**AGENDA
CITY OF CEDAR FALLS, IOWA
PLANNING AND ZONING COMMISSION MEETING
WEDNESDAY, FEBRUARY 13, 2019
5:30 PM AT CITY HALL**

TO: Planning and Zoning Commission
FROM: Iris Lehmann, Planner II
Matt Tolan, Civil Engineer II
DATE: February 7, 2019
SUBJECT: Greenhill Village Townhomes II – Preliminary Plat

TO: Planning and Zoning Commission
FROM: Iris Lehmann, Planner II
DATE: February 7, 2019
SUBJECT: Greenhill Village Townhomes II – Site Plan

PROJECT NO.
563
SHEET NO.
1 OF 2

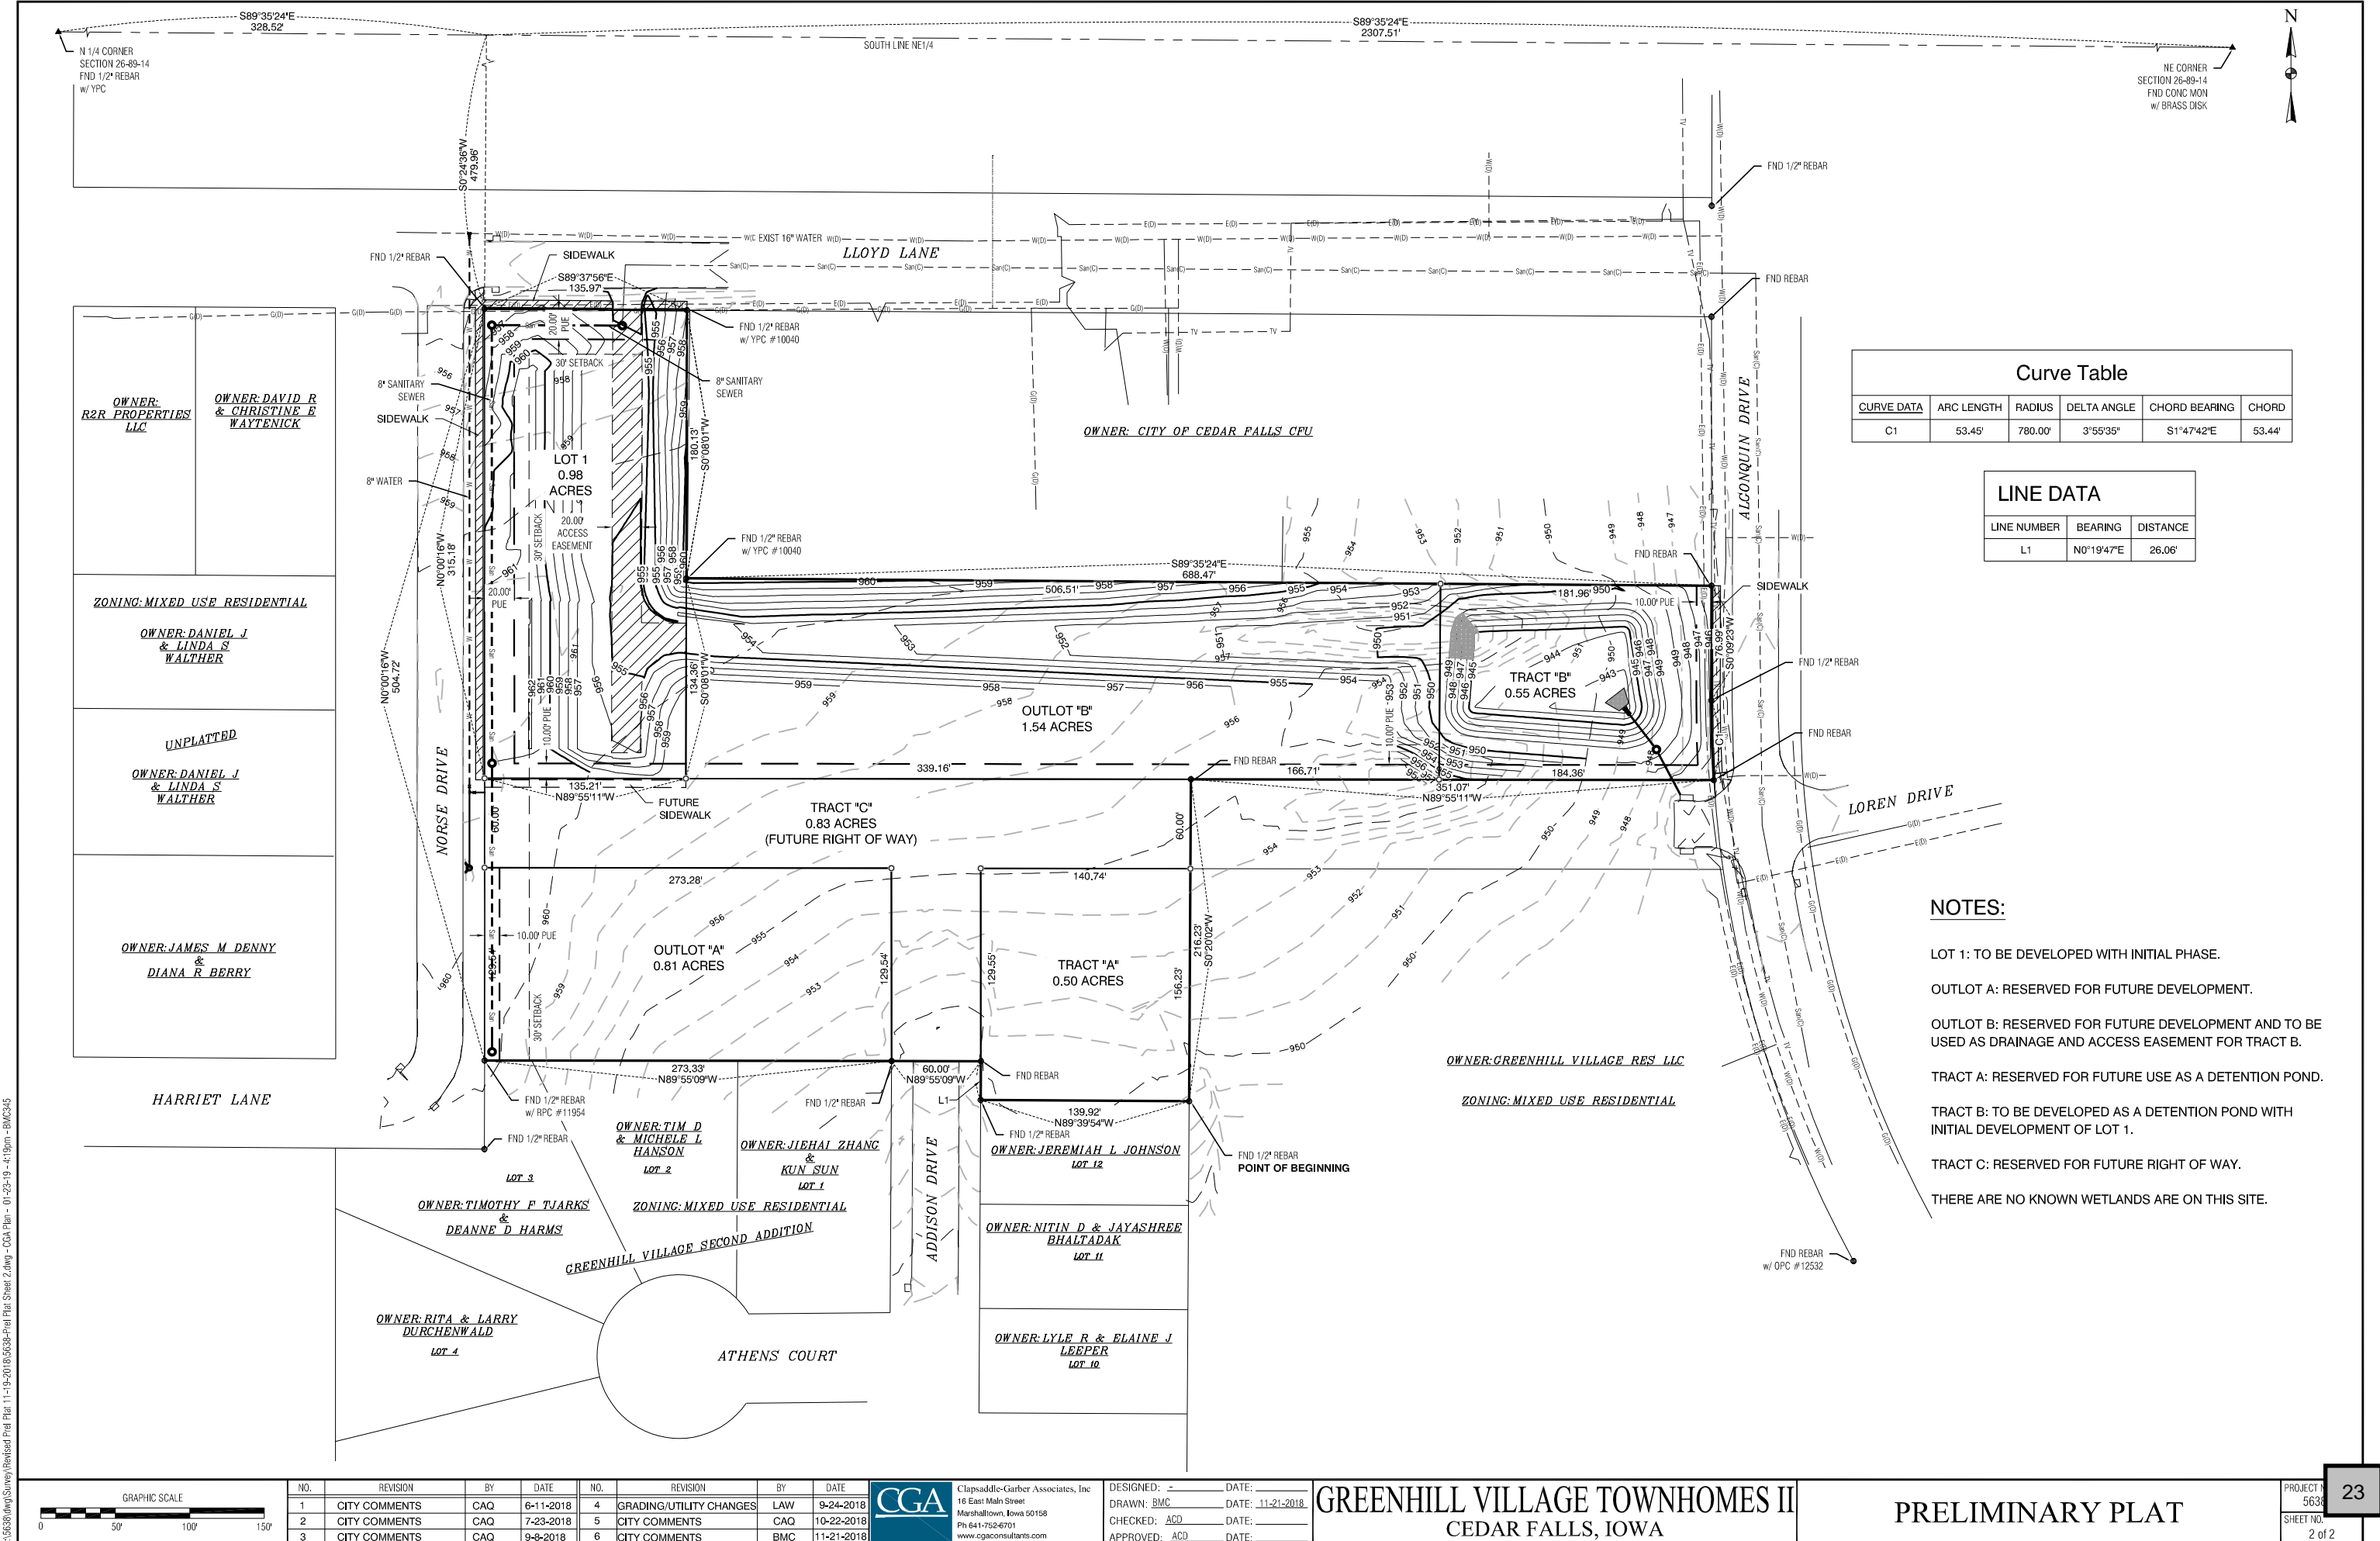
3. Add a public sidewalk on the east side of Tract "B".
4. A note about wetlands should be shown.
5. A utility easement needs to be shown of the North line of Lot 1 for the sanitary sewer.

7. The boundary line of the addition needs to be a heavier line weight than the interior lot lines
8. On Sheet 2 of 2 remove "Lot 5 0.57 acres" language from the Plat

9. Deed of Dedication – will be finalized with the Final Plat
10. Submit final stormwater management report at time of construction plans.

PROJECT NO.	56
SHEET NO.	C.100

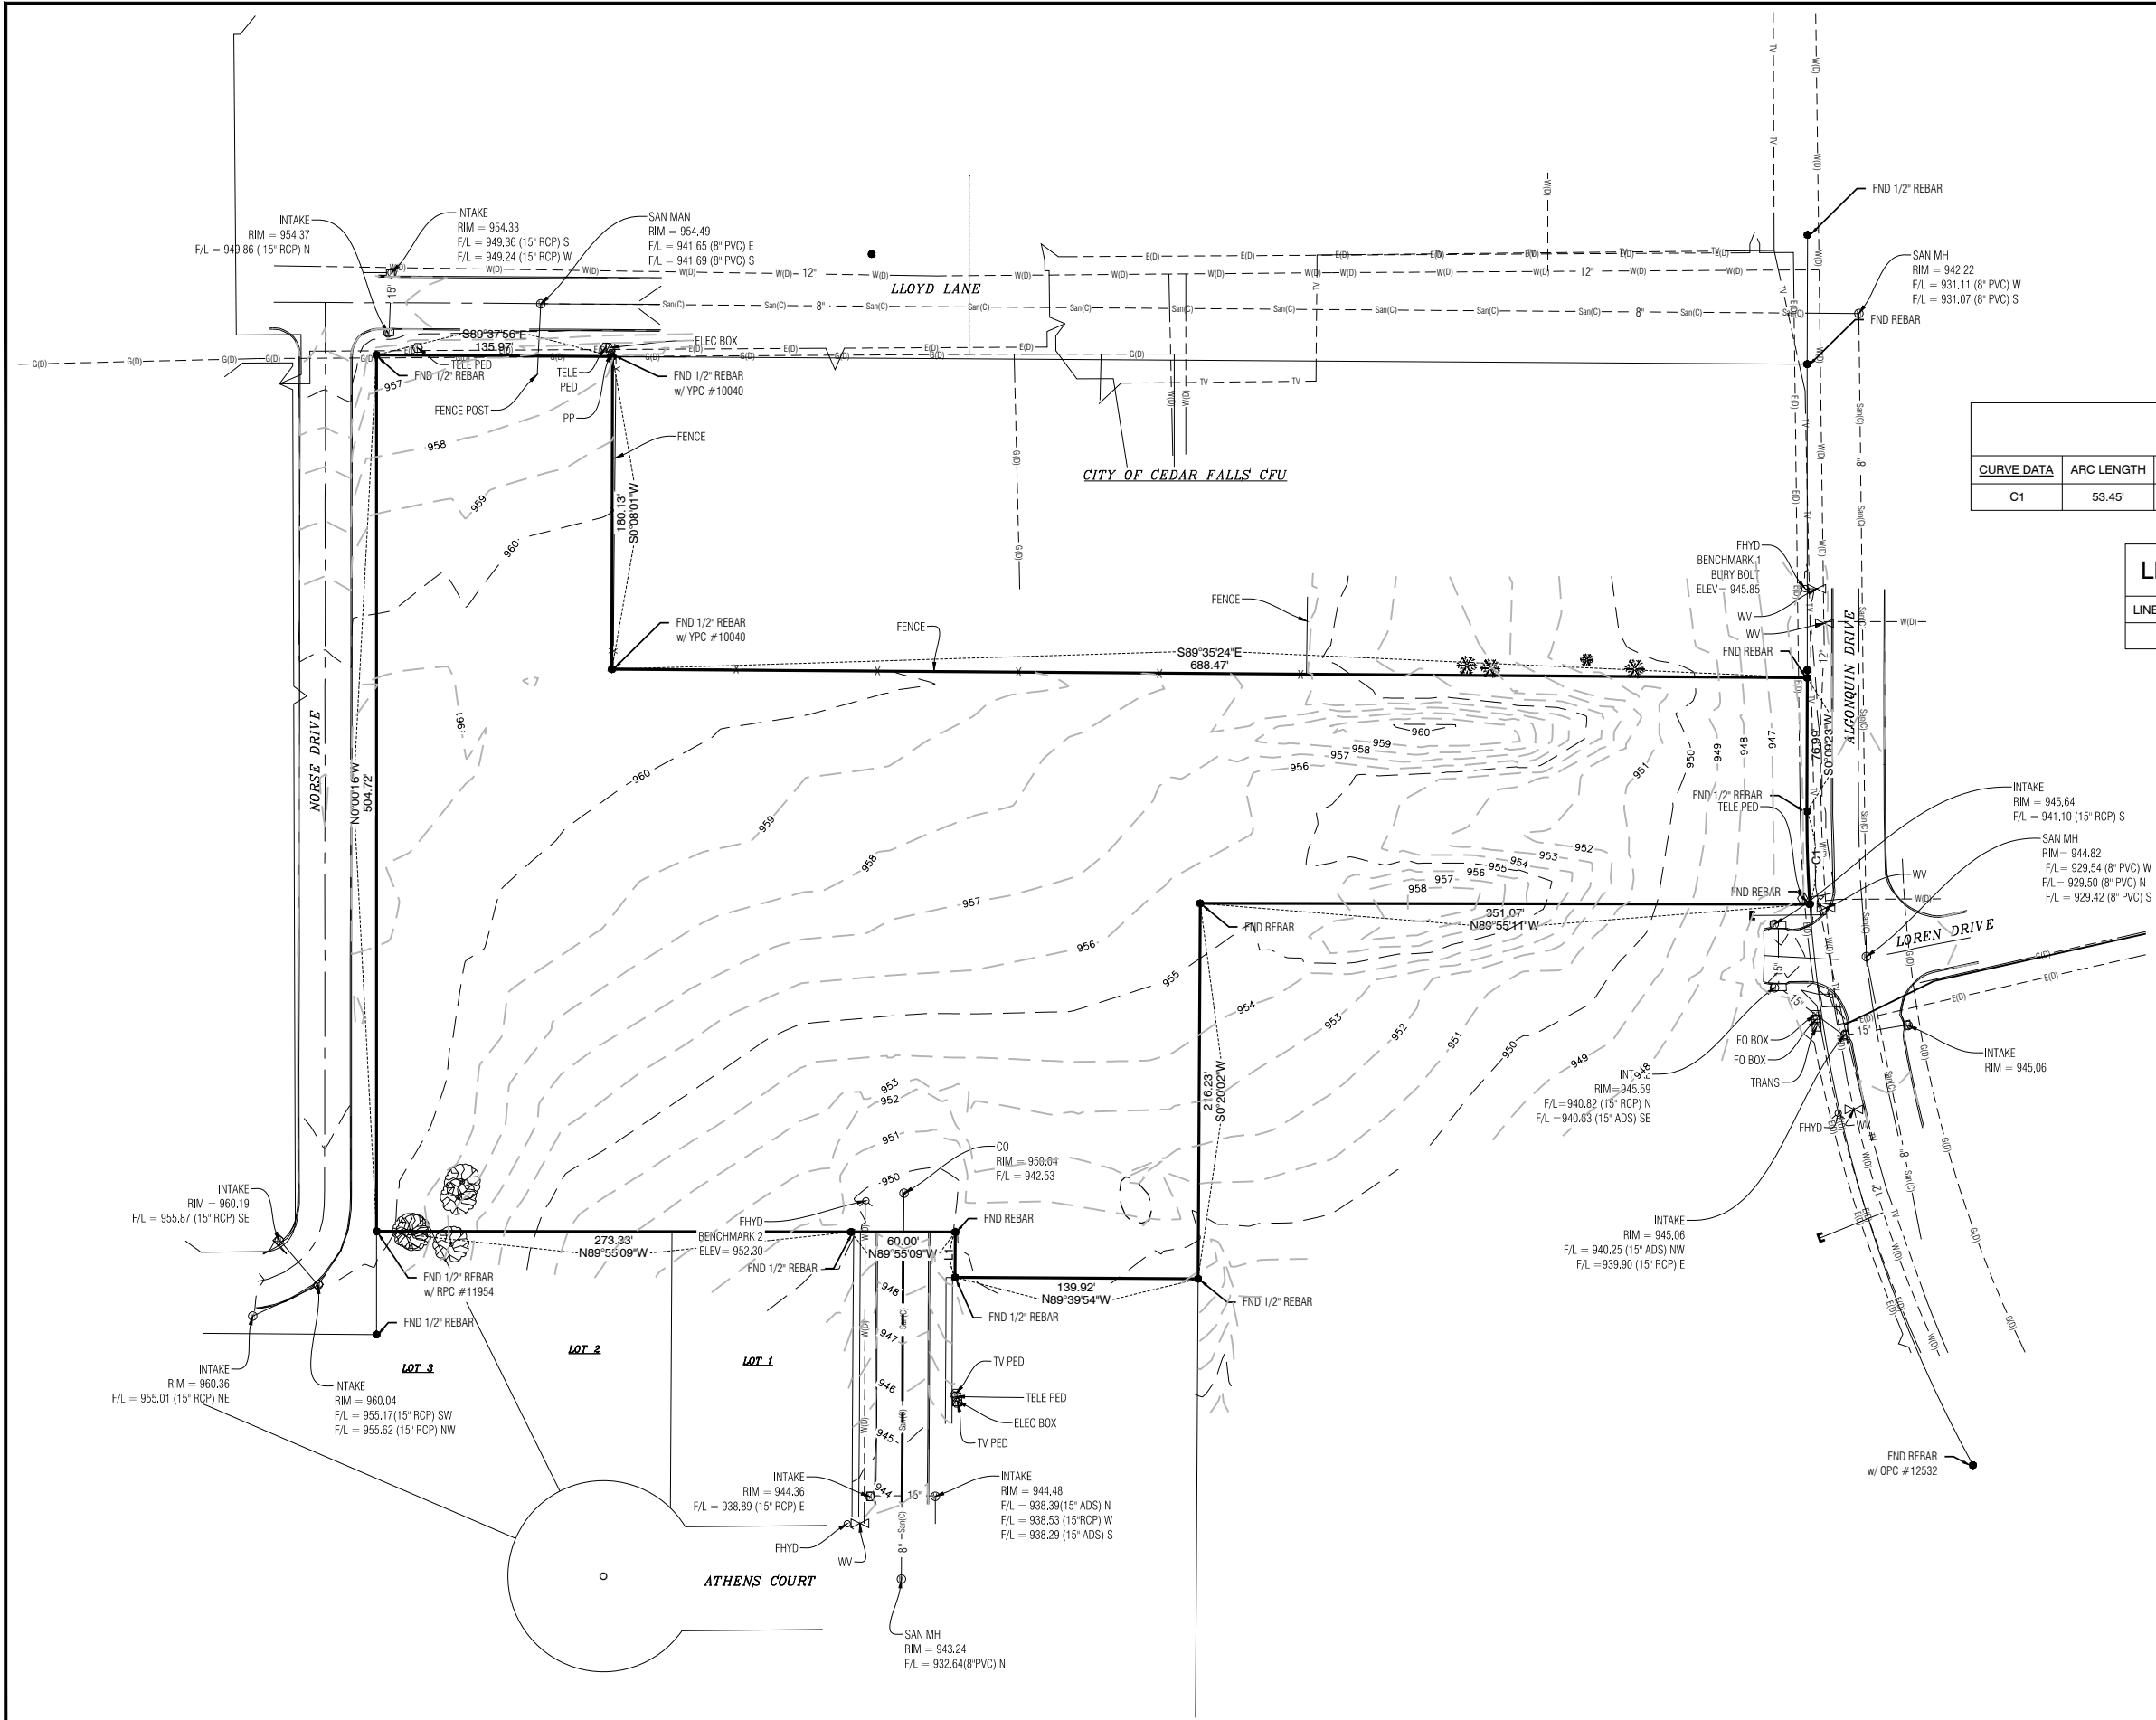
6. Revise and update sheet C.100 accordingly with any Preliminary Plat revisions
7. Submit final stormwater management report at time of construction plans.

PROJECT NO.	56
SHEET NO.	C.200

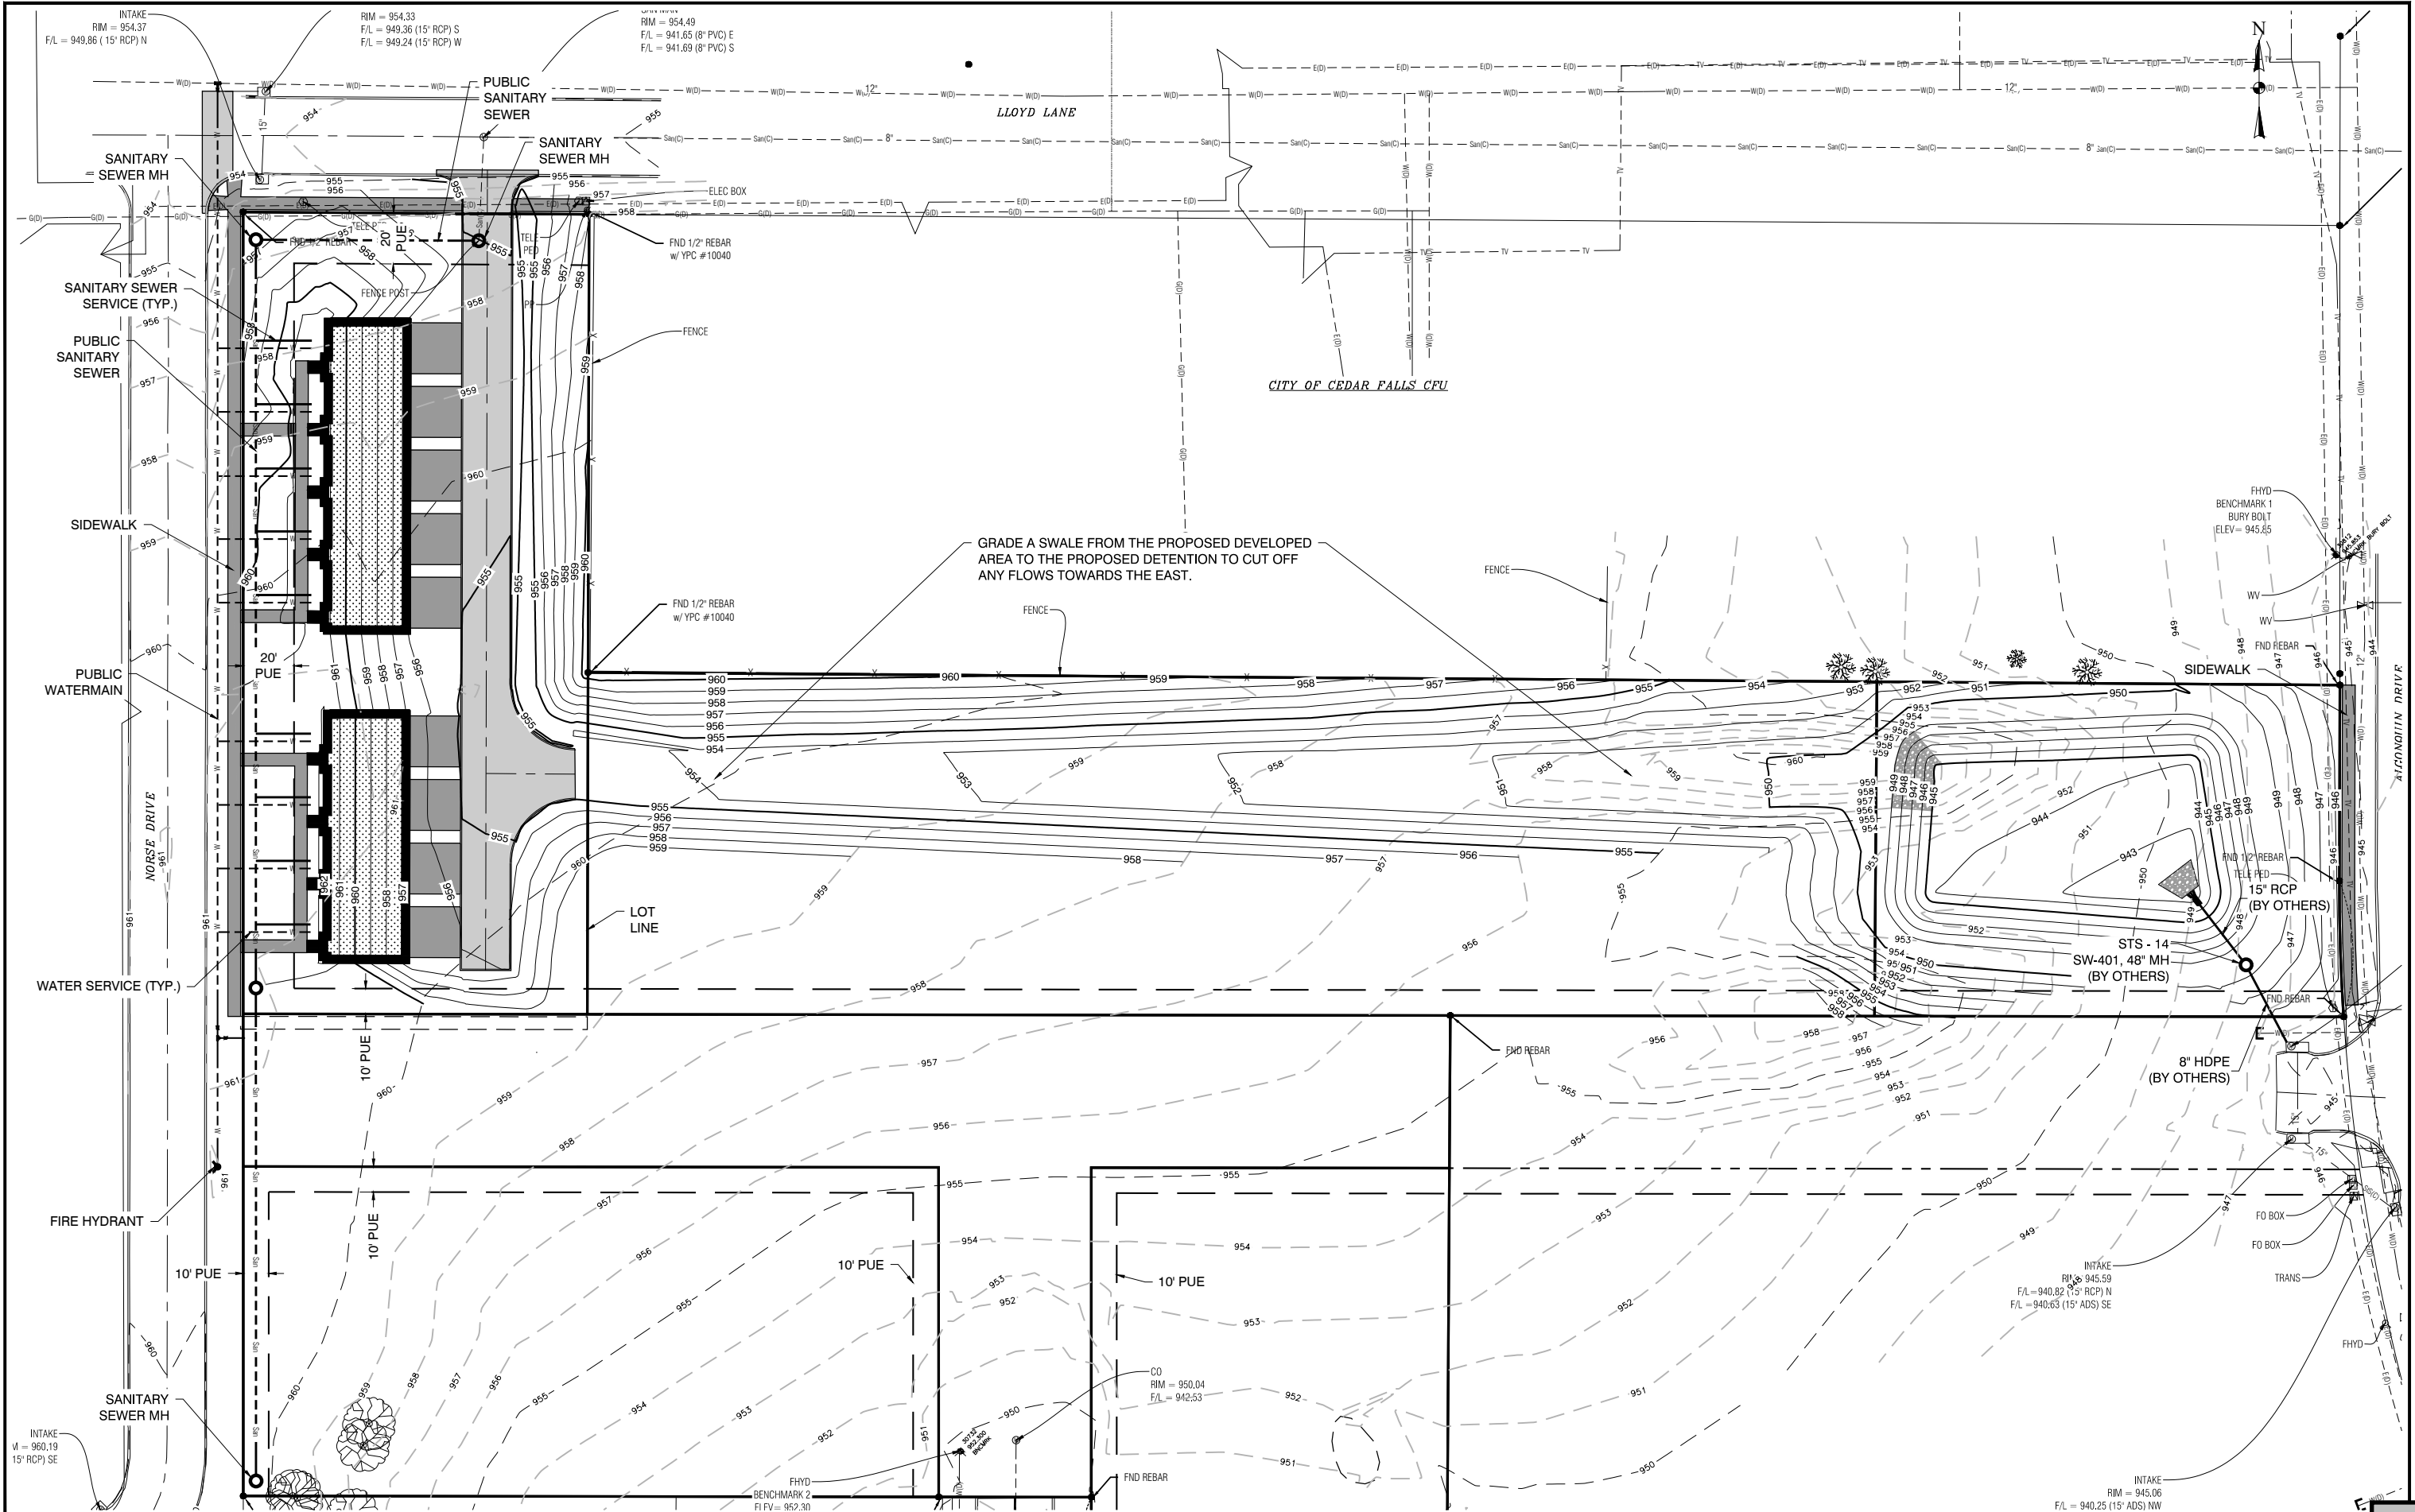
8. On Sheet No.C.200:
 - a. Update the height details of the building so to be consistent with the elevations (should be 34' 11 1/4 ").
 - b. Site triangle details have not been provided.
